**Subject: PALEN SOLAR HOLDINGS, LLC'S RESPONSE TO CEC STAFF DATA REQUEST SET 2 (19-39)  
PALEN SOLAR ELECTRIC GENERATING SYSTEM  
DOCKET NO. (09-AFC-7C)**

**RESPONSE TO CEC STAFF DATA REQUEST SET 2 (19-39)**

**PALEN SOLAR ELECTRIC GENERATING SYSTEM**

(09-AFC-7C)

Figure DR149- 1: Heliostats retinal irradiance – worst case

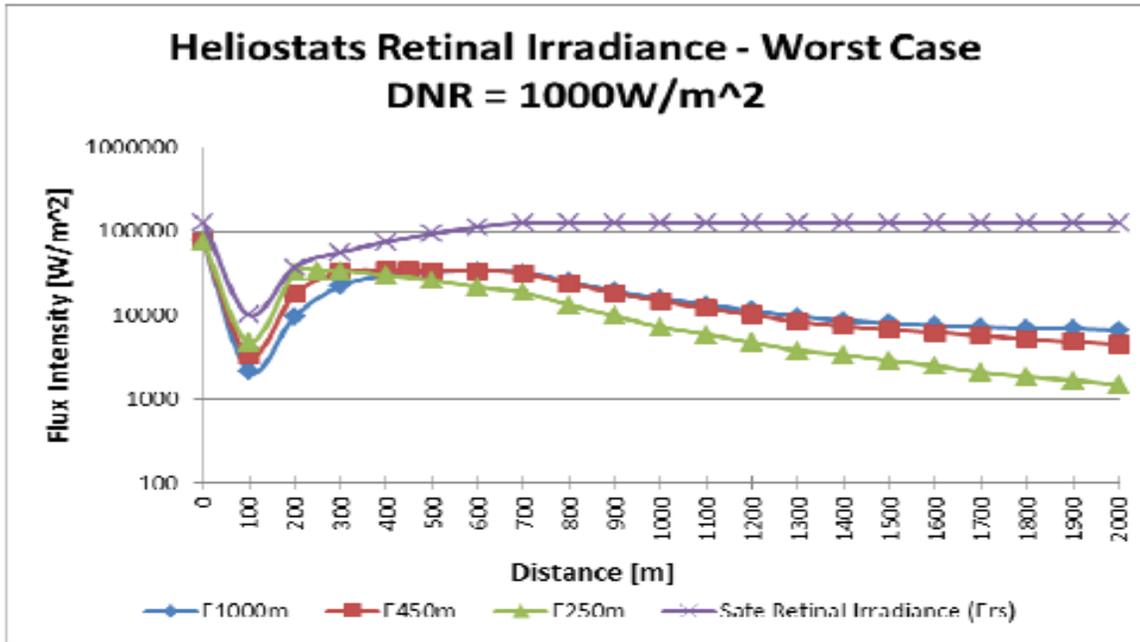
**Data Request 35.** Please provide the predicted luminance of the solar receiver steam generators from each of the Key Observation Points (KOPs), including those described in Data Request 39, below.

The luminance of the receiver is lower than  $10^6$  cd/m<sup>2</sup>. The sun luminance at noon is  $1.6 \cdot 10^9$  cd/m<sup>2</sup>. The receiver luminance is computed as if you are viewing it from the same elevation as the receiver. The actual luminance on the ground should be slightly lower. Luminance does not change significantly with distance. However, the effect of an object of certain luminance on the retina depends on the angular size of the object, which decreases with distance.

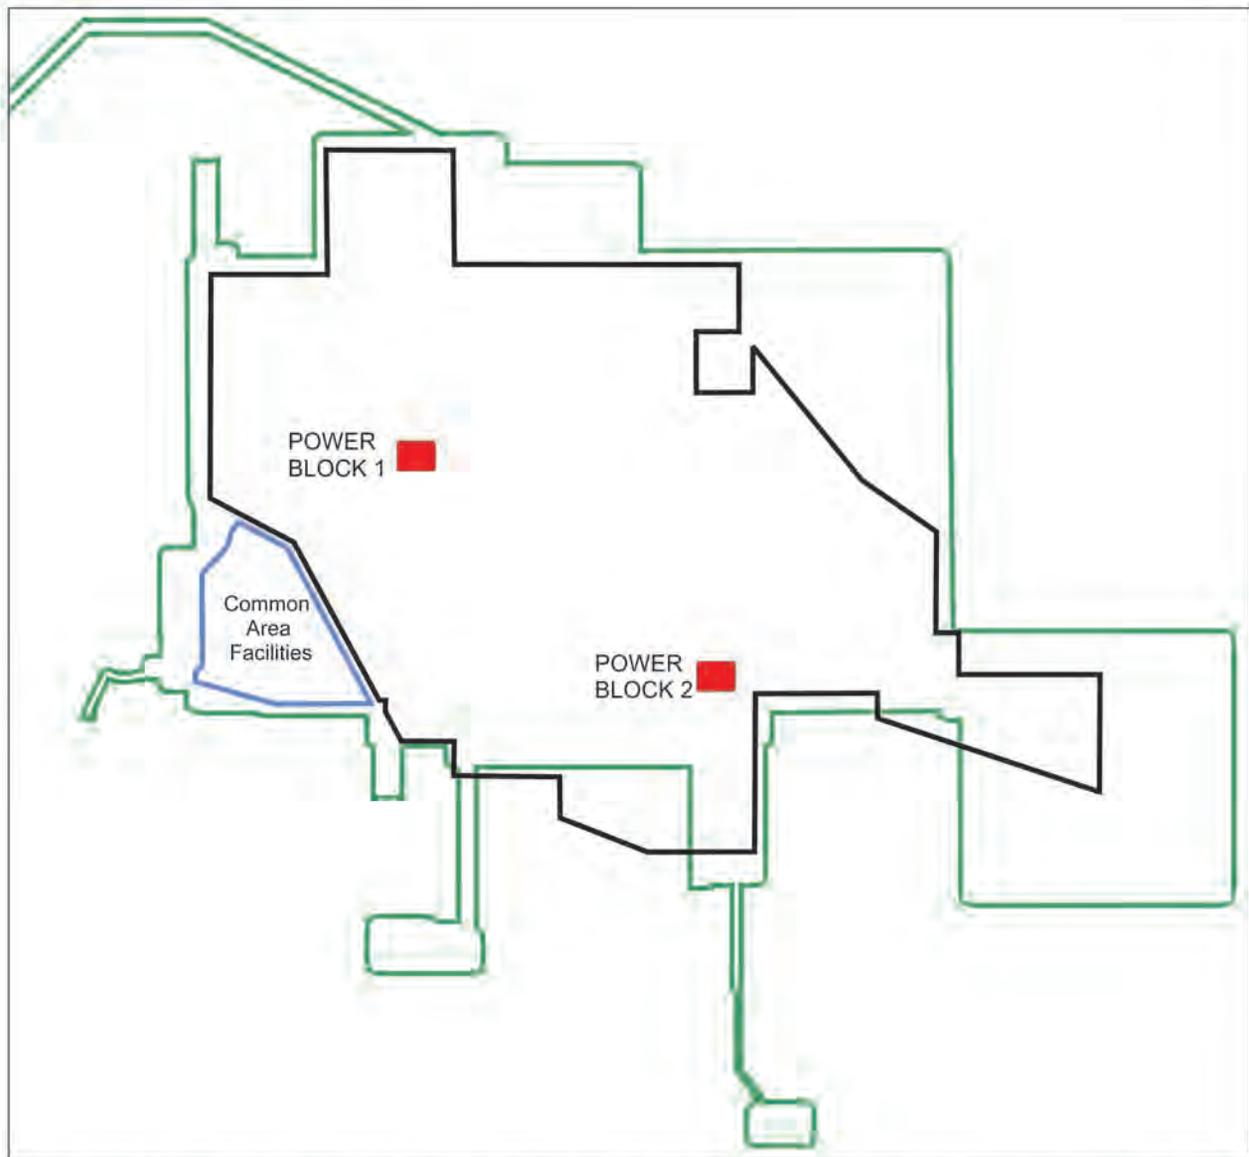
**Data Request 24.** *Please design and conduct a class II pedestrian archaeological survey of the original project area sufficient to verify the statistical validity of the cultural resources inventory for the project area as documented in 2009 and 2010.*

The project has since been modified (Figure 1) by reducing the footprint's acreage on the northeast corner and by extending the project's footprint to the south in two small areas. Additional studies have been requested by the BLM and the CEC. These additional studies include:

Based on recommendations from BLM, a trenching program has been designed to further evaluate the two tower base locations for the PSEGS project. Tower bases are octagonal, and 195 feet (60 m) in diameter. Tower foundations will be dug to a depth of approximately 4 meters (12 ft). As shown in Figures 2 and 3, both towers are to be located in the mid-fan portion of the Corn Springs alluvial fan. Mid-fan sediments have been modified by weak pedogenesis, and Holocene erosion of Pleistocene surfaces and are subject to continuing occasional erosion or deposition in ephemeral alluvial channels. Further disturbance has occurred through bioturbational processes, primarily rodent activity. These processes are likely to result in dislocation of artifacts and/or modification of any archaeological features that may be present. Although neither tower location is in a concentration of currently active washes, runoff occasionally flows in small natural channels traversing the fan surface in both locations. Channel directions closely parallel the northeastward (N40°E) slope direction, with an incline varying between about 15-18 m/km (75-100 ft/mi) in the area of the towers. No test excavations were conducted in the tower base areas in previous archaeological or geoarchaeological studies, and no prehistoric isolated finds, archaeological sites or features were discovered in either tower location (Tennyson and Apple 2010). Subsequent geoarchaeological investigations of the area (Nials 2013) suggest that additional features or sites are unlikely, although the possibility of additional manifestations cannot be entirely dismissed.
